(Cover Letter for Dominic Vecchione Letter, Submitted by Joanne Cullinane, precinct 21)

I am providing comments to the plans submitted for the property at 126 Broadway, Arlington MA.

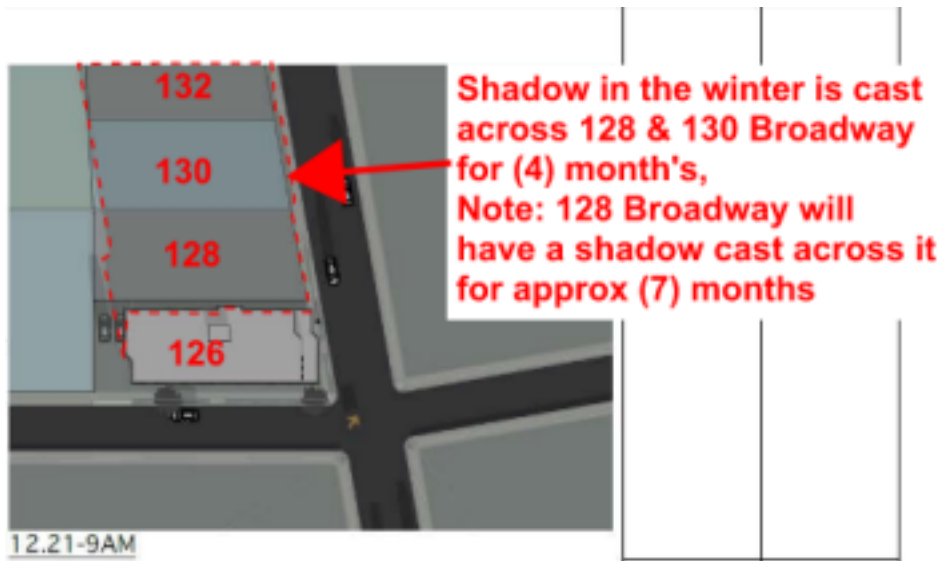
The Shadow study (below) does not properly show that there is an impact to the property at

128, 130 & 132 during the winter for (4) months +/- and that the property at 128 Broadway

will have a shadow cast on it for approx. (7) months a year. A project should not have such a

Large impact on its adjacent neighbors.

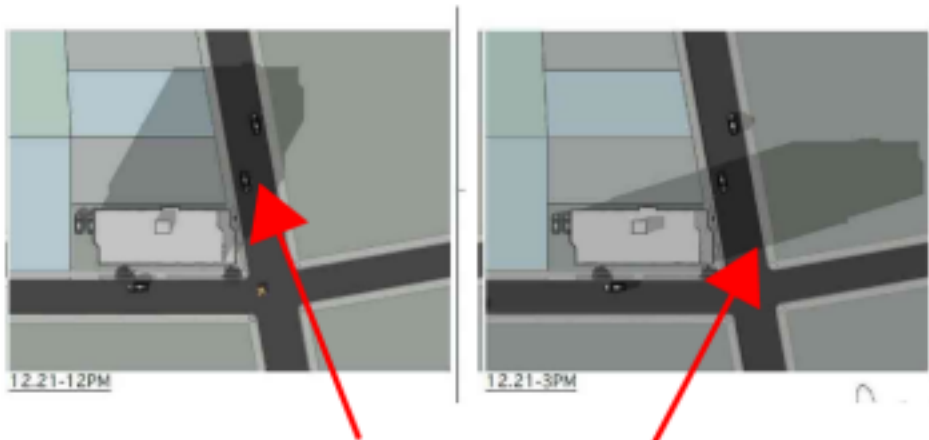
The

Shadow study(below) and the perspective (above) do not meet the Town of Arlington

Design guidelines for commercial Corridor, this will create a Canyon effect and is not

inviting at the street

Scale of project on the right will overpower the existing homes.

The above is a comparison of a well-known building in town to demonstrate what the height will be
